Access Compliance Report

Public Rights-of-Way

Intersection ID: 45985	Main Street: MASON_MILL_PL	Cross Street: WILLOW_VALLEY_CT	Location: SE
ADA ID: ECC5AEA17343	Ramp Type: PerpDiag	Initial Pass/Fail: Fail	Overall Compliance: No
Severity Score: 22.5			
Codes/Mitigation Info/Possible Solution		Field Measurements/Component Compliance

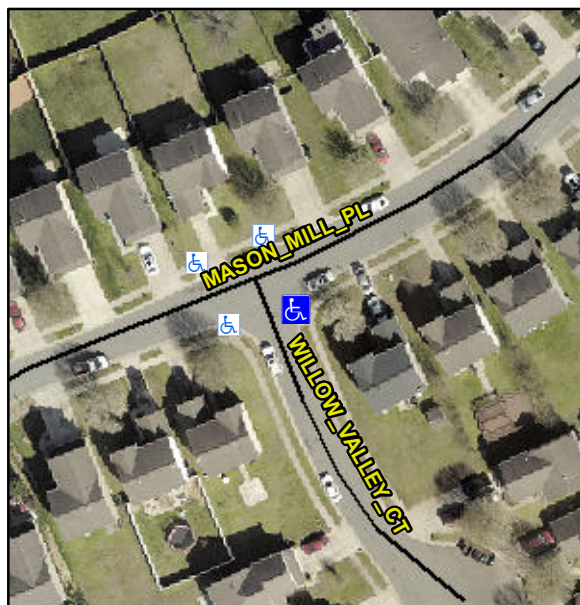
R304.5.1, R304.2.2, R304.5.3

Compliance	Description	Data	Compliance	Description	Data
N/A	Ramp Length (in)	48.0	No	Ramp Slope (%)	10.8
No	Ramp Width (in)	41.0	No	Ramp XSlope (%)	4.6
N/A	Flare Type LT	N/A	N/A	Flare Type RT	N/A
N/A	Flare Slope LT (%)	N/A	N/A	Flare Slope RT (%)	N/A
N/A	Flare Traversable LT?	N/A	N/A	Flare Traversable RT?	N/A
N/A	Landing Length (in)	N/A	N/A	DWS Provided?	N/A
N/A	Landing Width (in)	N/A	N/A	DWS Contrast?	N/A
N/A	Landing Slope (%)	N/A	N/A	DWS Length (in)	N/A
N/A	Landing X Slope (%)	N/A	N/A	DWS Full Width?	N/A
N/A	Landing Curb? (Y/N)	N/A	N/A	DWS Offset (in)	N/A
N/A	Shared Landing?	N/A			
N/A	Gutter Ponding?	N/A	N/A	Gutter Slope (%)	N/A
N/A	Gutter Lip Ht (in)	N/A	N/A	Gutter X Slope (%)	N/A
N/A	Painted X Walk1?	No	N/A	Painted X Walk2?	No
	X Walk 1 Direction	To N		X Walk 2 Direction	To W
N/A	X Walk 1 Width (in)	N/A	N/A	X Walk 2 Width (in)	N/A
	X Walk 1 Slope (%)	2.4		X Walk 2 Slope (%)	0.8
	X Walk 1 X Slope (%)	2.7		X Walk 2 X Slope (%)	1.9

Remove & Replace Curb Ramp With Two New Directional Ramps or Equivalent.
